ADDENDUM 2

CSP 22-68

Memorial Middle School Heating & Air Condition (HVAC) Improvements Funded through the Elementary & Secondary Emergency Relief (ESSER) Funds

April 8, 2022

SHEET NUMBER:
MD3.12

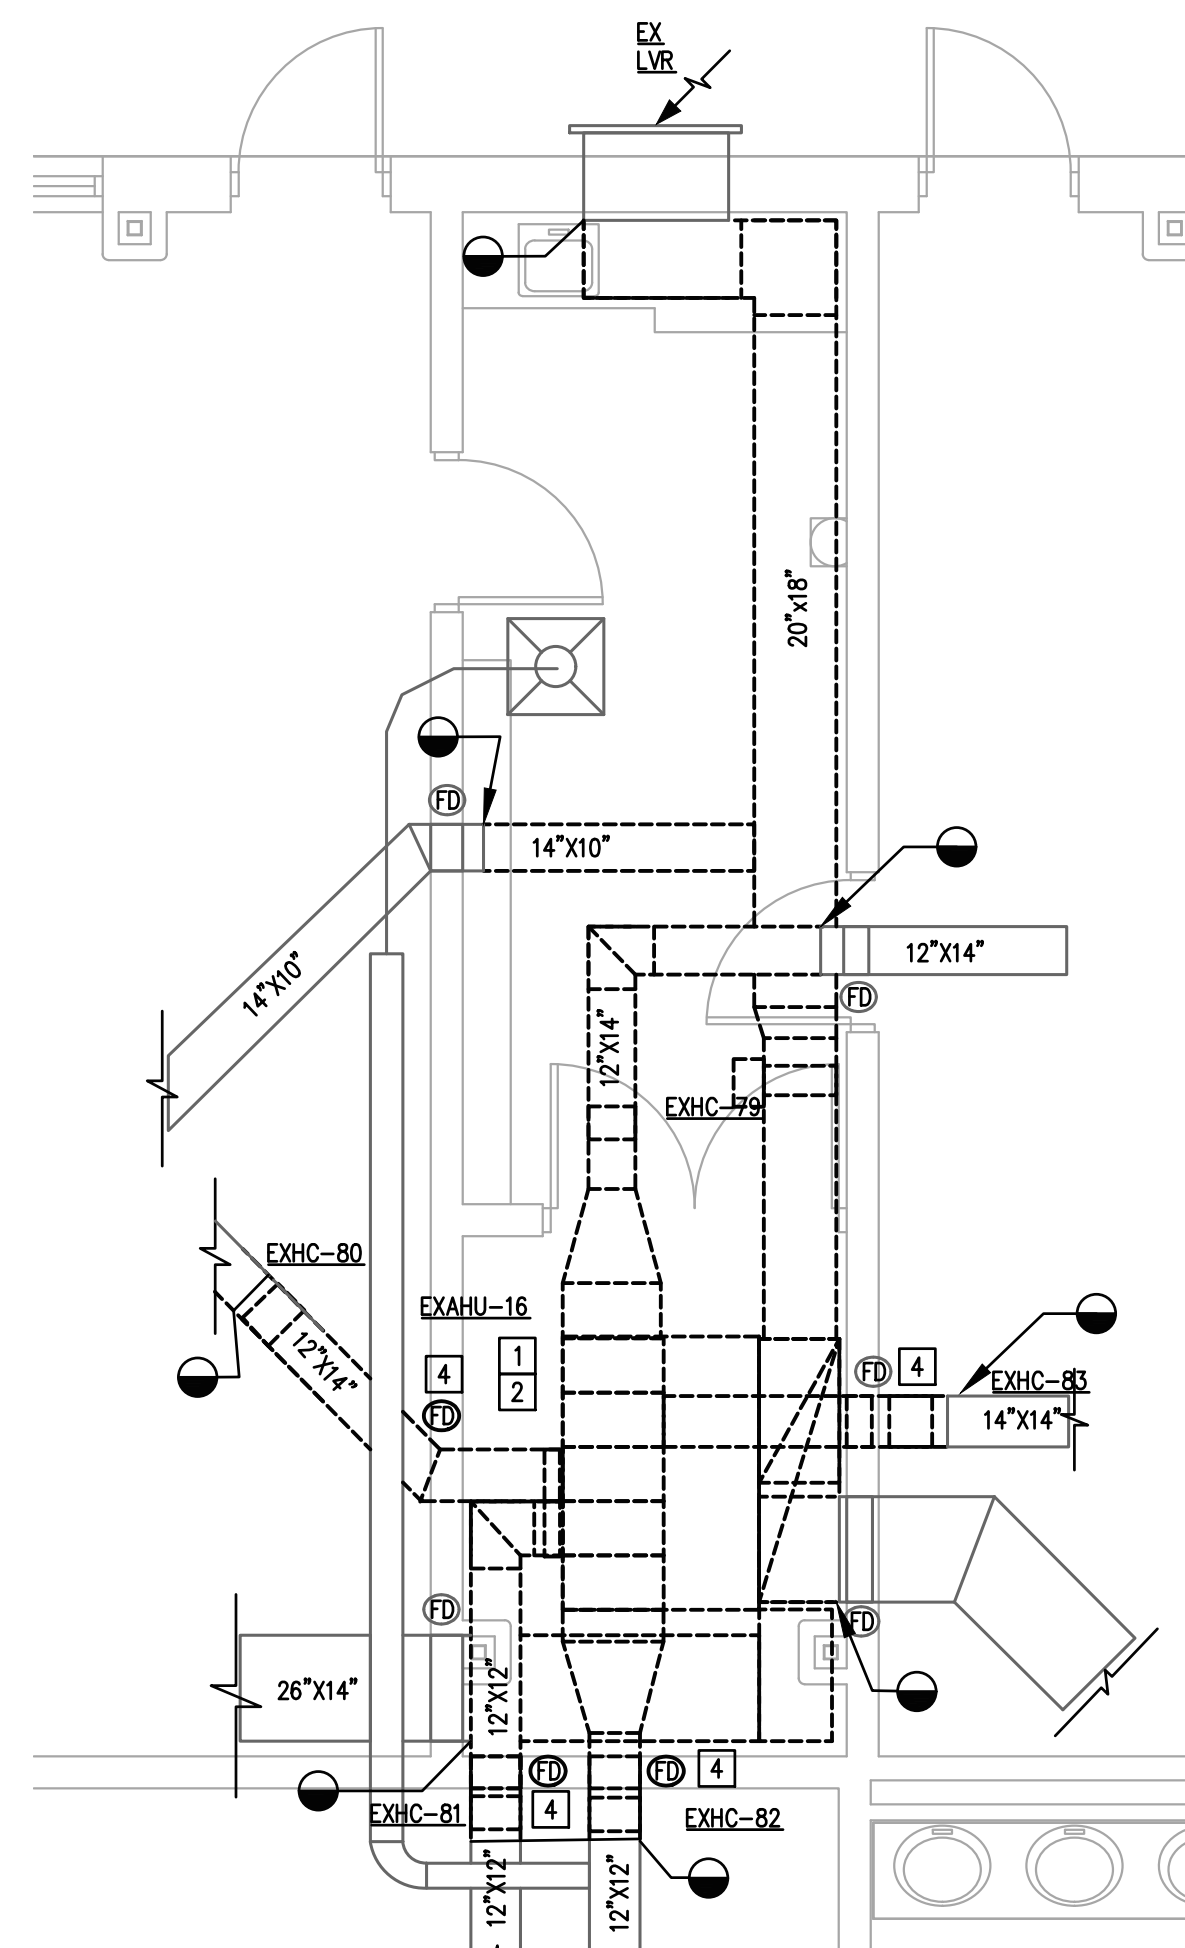
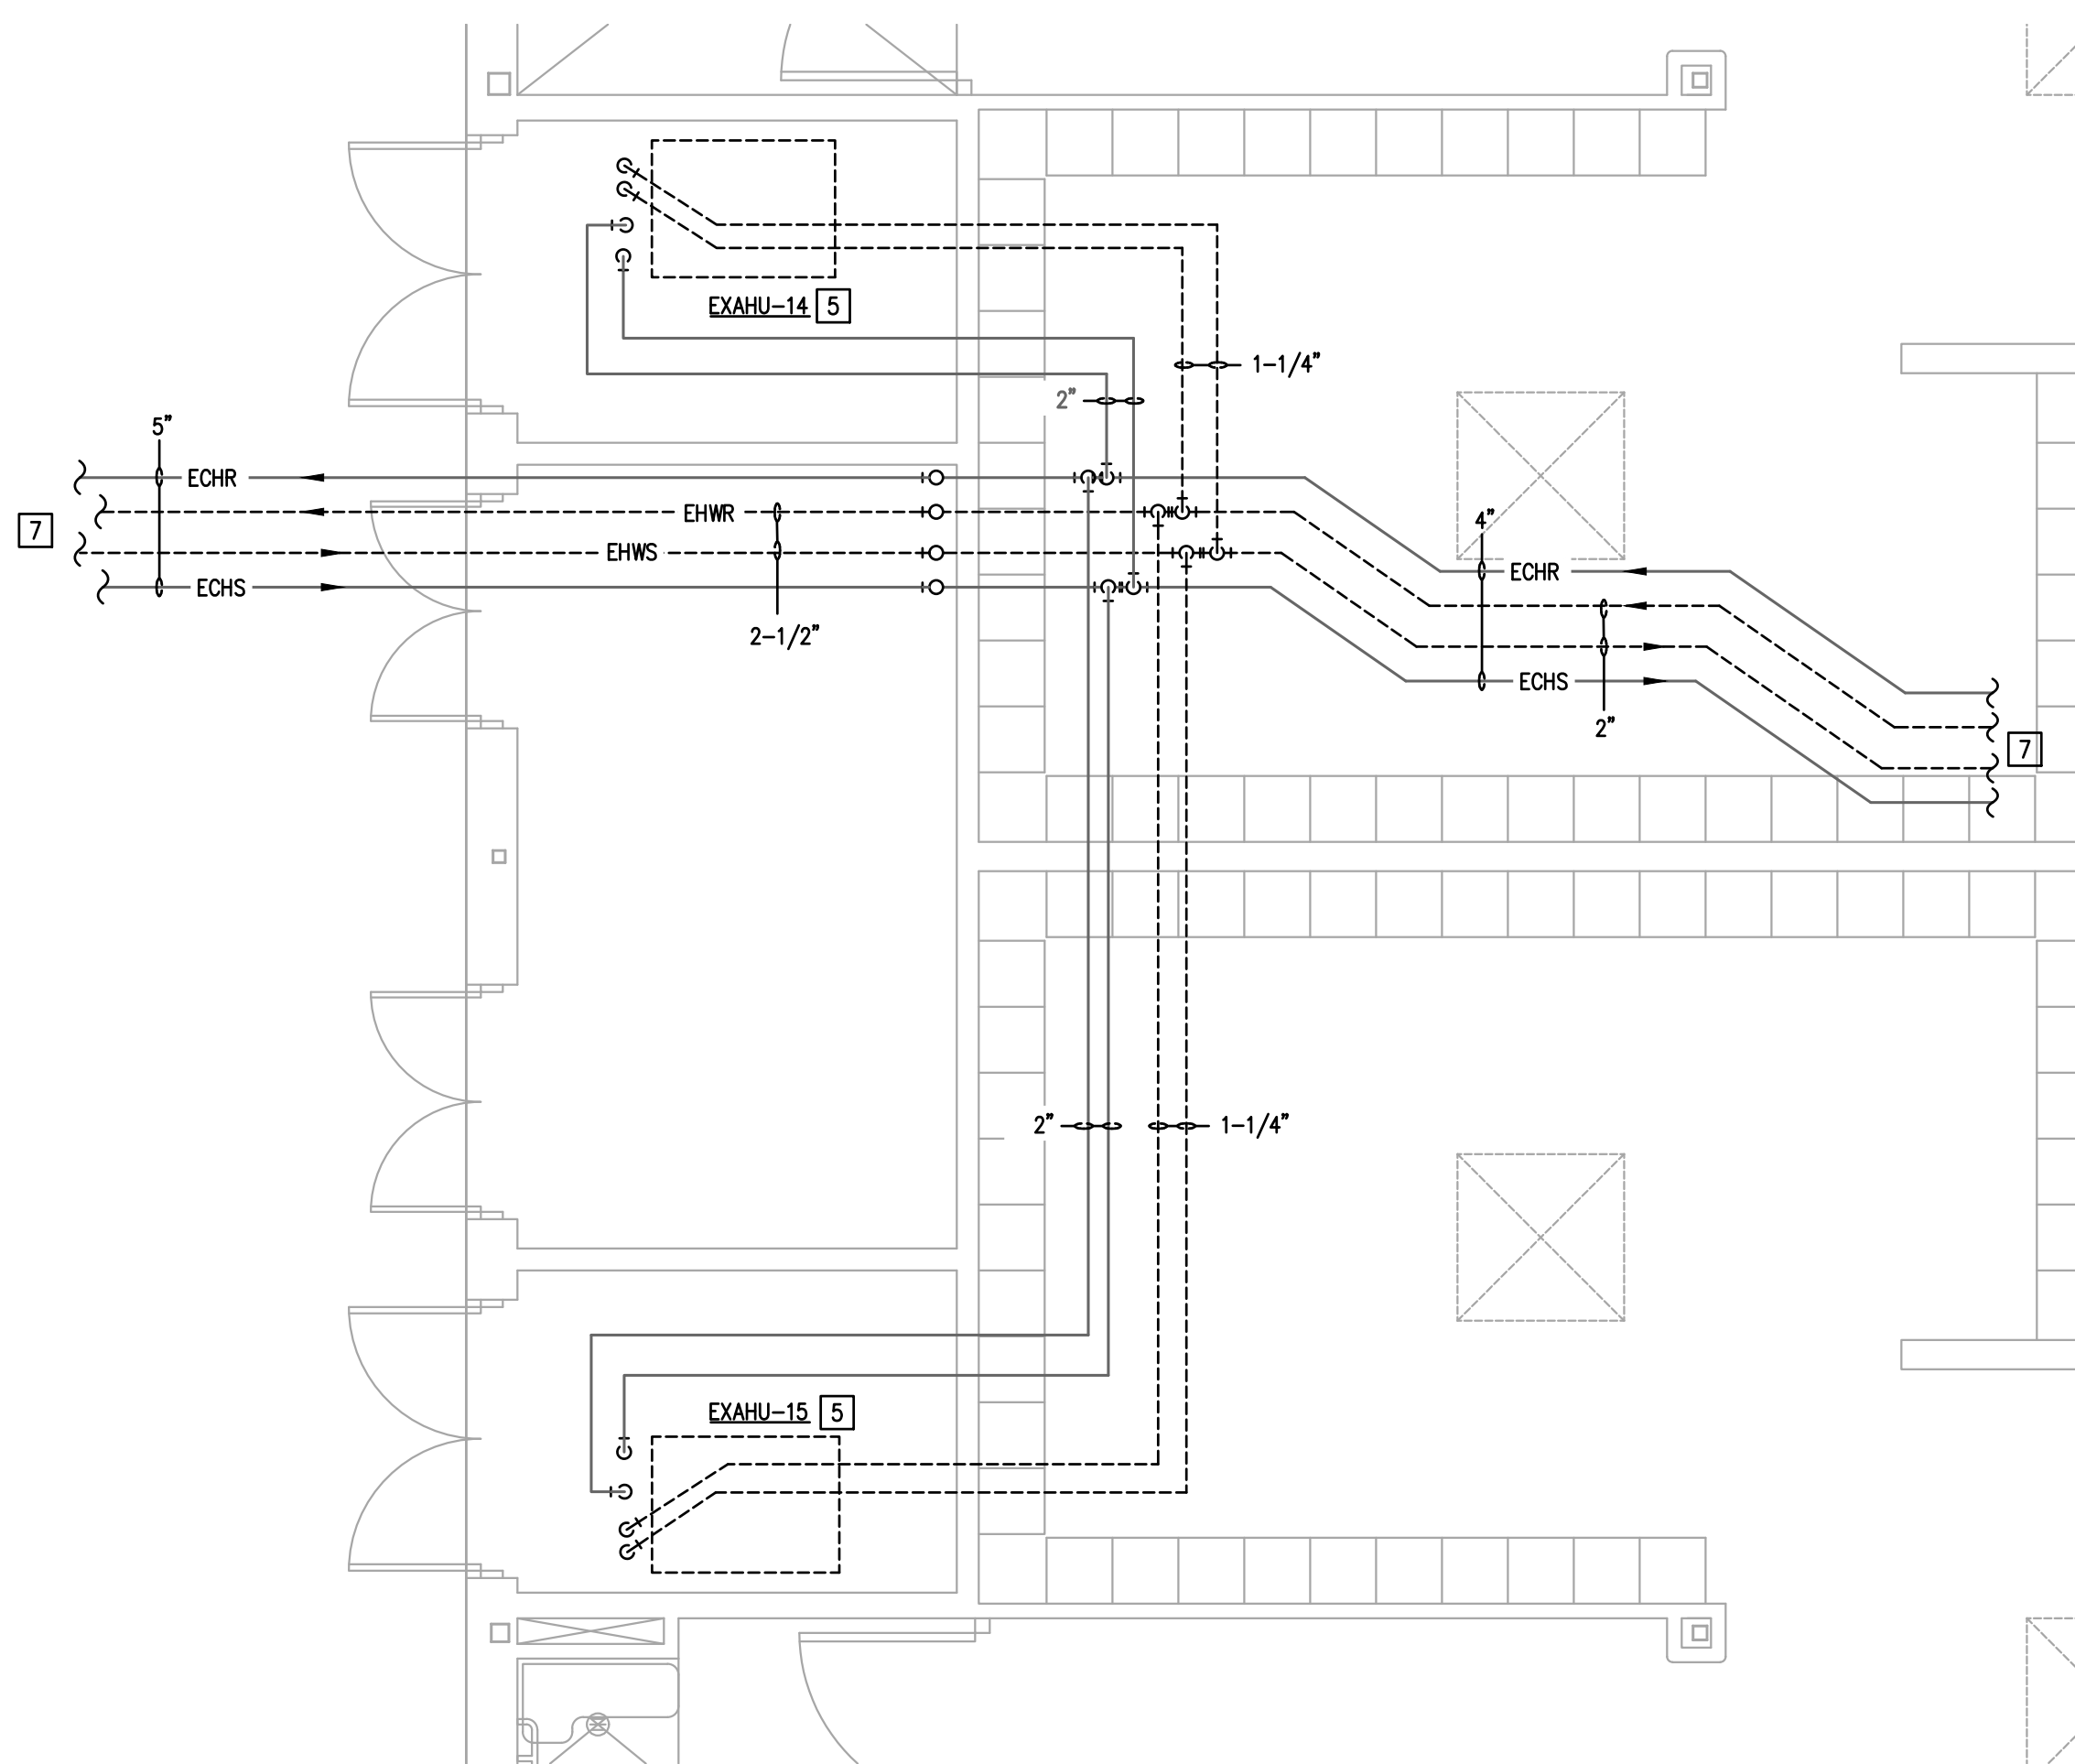
Item 05 SHEET MD3.12 – ENLARGED MECHANICAL DEMO PLAN

A. Revised keyed notes 3 and 10.
